**Re: Welland Hydro-Electric System Corp. (Welland Hydro)
2017 Distribution Rate Application
OEB Staff Interrogatories
OEB File No. EB-2016-0110**

OEB Staff Interrogatories
2017 Cost of Service Rate Application
Welland Hydro-Electric System Corp. (Welland Hydro)
EB-2016-0110
February 27, 2017

Figure 5-12: Historical SAIDI and SAIFI performance – MED excluded

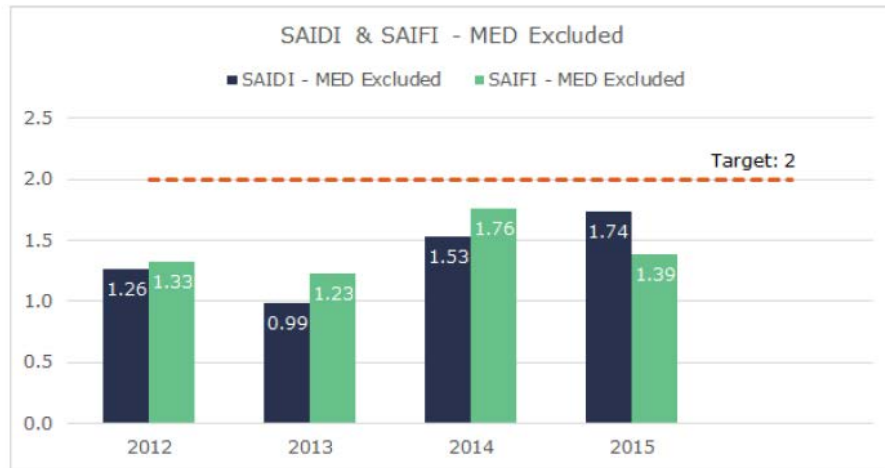
- (a) Why are SAIDI and SAIFI increasing after excluding major event days?
- (b) Should Welland Hydro be targeting ongoing improvement in these metrics after excluding MED's and Loss of Supply, since that portion of the metric is more subject to Welland Hydro's direct control?

Figure 5-18: Summary of defective equipment outages

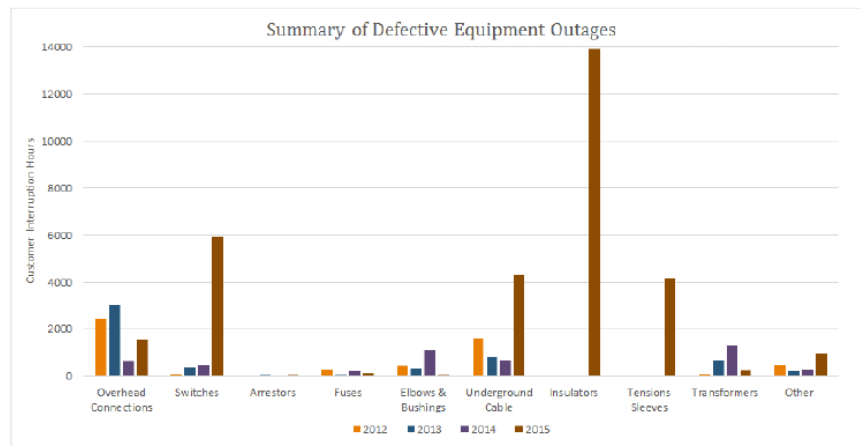
- (a) Explain the reasons behind the exceptionally high impact of insulator failures in 2015.
- (b) What action is Welland Hydro taking to avoid similar outcomes in future years?

Figure 5-24: Historical percentage line loss

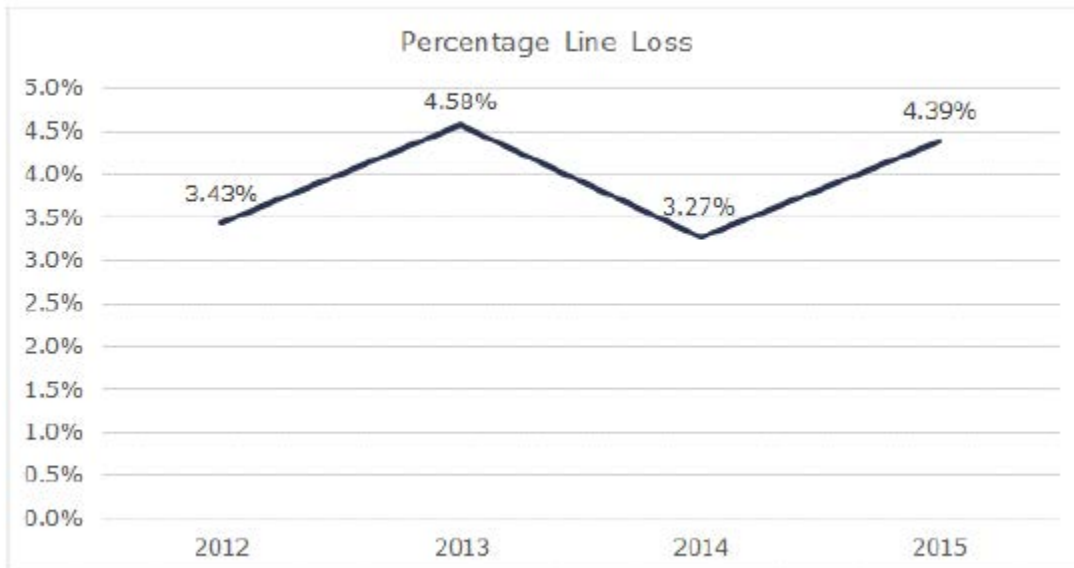
- (a) Inter-annual line losses appear to be very volatile. Is this variability caused solely by differences in ambient temperatures?
 - i. If yes, please explain the mechanisms that link ambient temperatures to such volatile loss results.
 - ii. If no, please identify the other factors that impact annual losses.
- (b) Given Welland Hydro's ongoing capital investments in efficiency initiatives such as voltage conversions, why are line losses not generally trending downward over this period? Please provide details.

Figure 5-27: Inputs/outputs of the asset management process used to identify and select projects

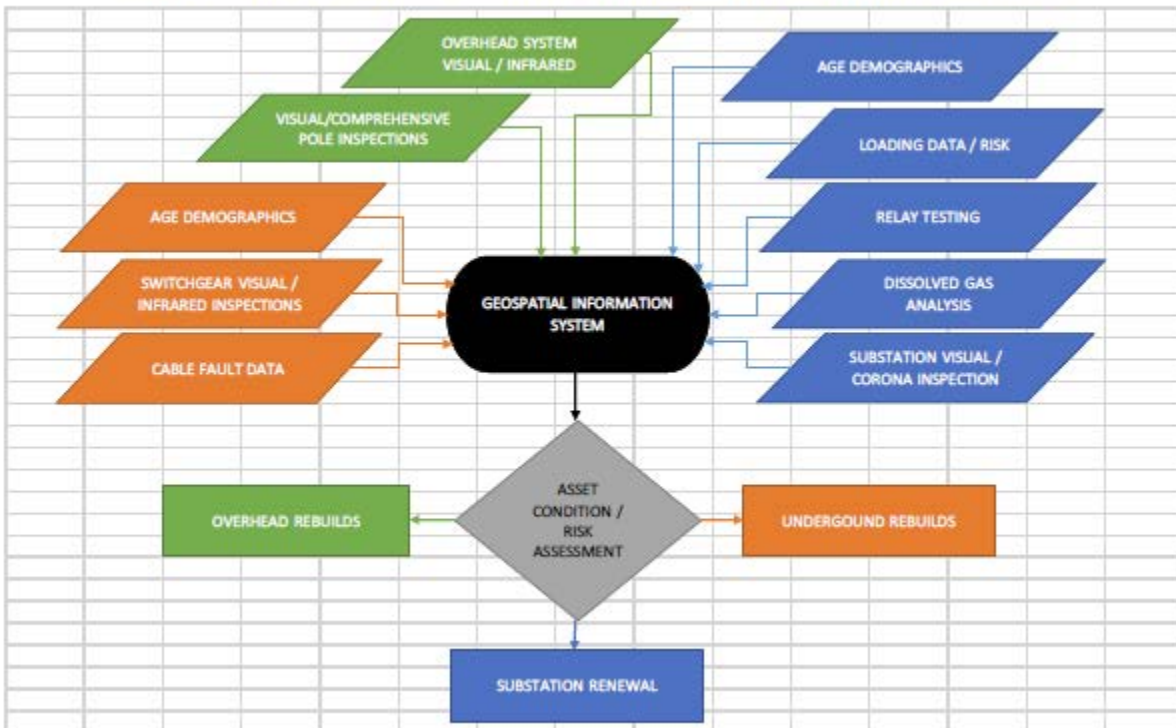
- (a) Please provide examples of Welland Hydro's use of both the data analytics and graphical analytics tools referenced in this excerpt, and provide links to planned Test Year capital expenditures.
- (b) When does Welland Hydro plan to implement a formal Asset Management Process?
- (c) Please explain in detail the activities and decisions that take place in the grey diamond entitled "Asset Condition/Risk Assessment" in Figure 5-27?

Figure 5-32: In-service dates of wood poles

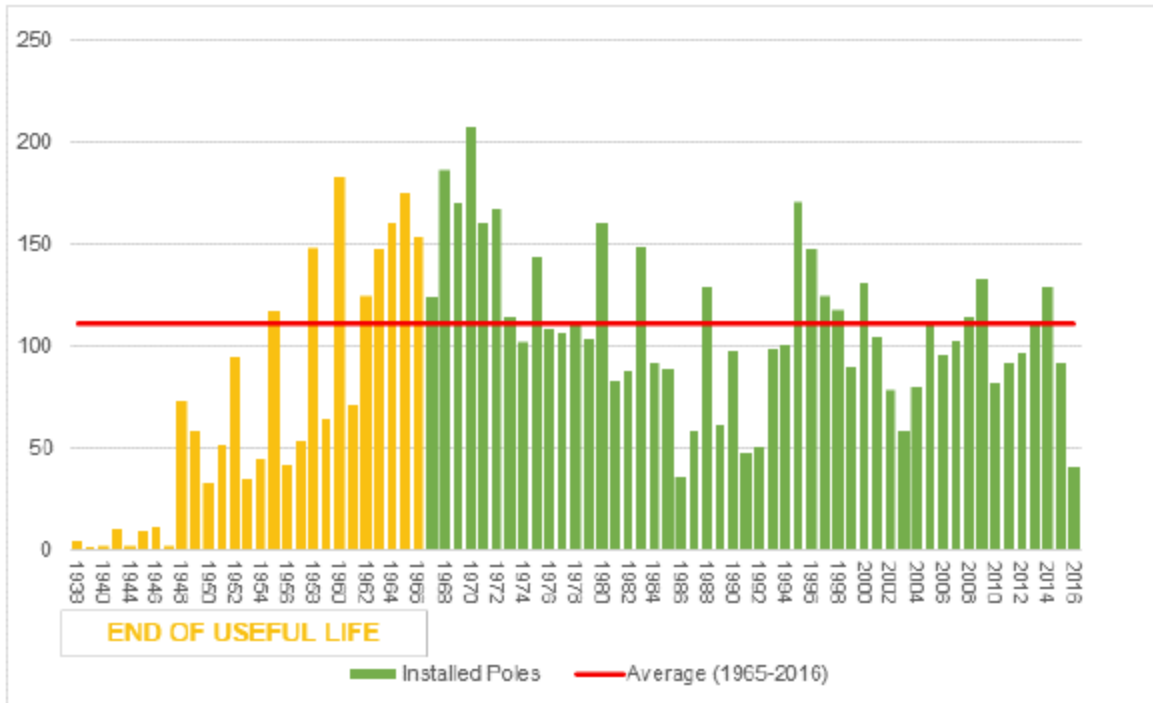
- (a) From the graph above, it seems as though the average age is not indicated. What is the average age of the wood poles currently in service?
- (b) Are all wood poles in Welland Hydro's system of the same species?
 - i. If not, does Welland Hydro apply the same 50-year useful life assumption for all species?
- (c) Considering the total count of poles identified as being significantly beyond "end of useful life", is that categorization appropriate for all the poles so identified?

Figure 5-33: In-service dates of distribution transformers

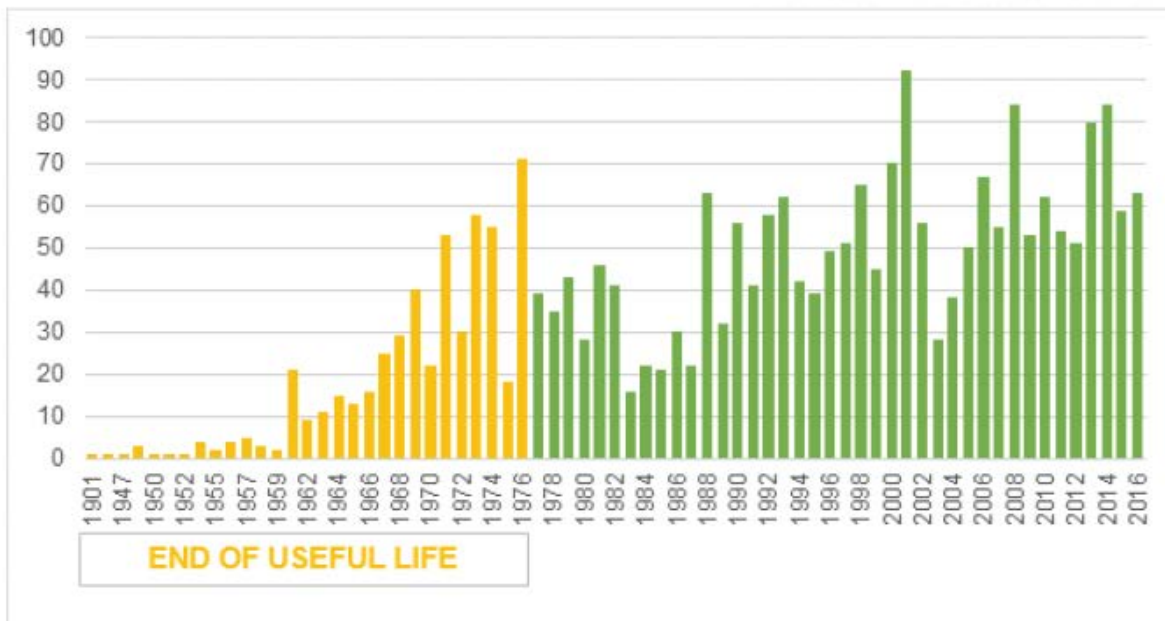
- (a) What sorts of “deficiencies introduce risk”, as referenced above?
 - i. How is the risk quantified?
 - ii. Who ultimately decides if the risk due to a specific deficiency is high enough to justify transformer replacement, and what criteria are applied in making that decision?
- (b) Considering the total count of distribution transformers identified as being significantly beyond "end of useful life", is that categorization appropriate for all the transformers so identified?
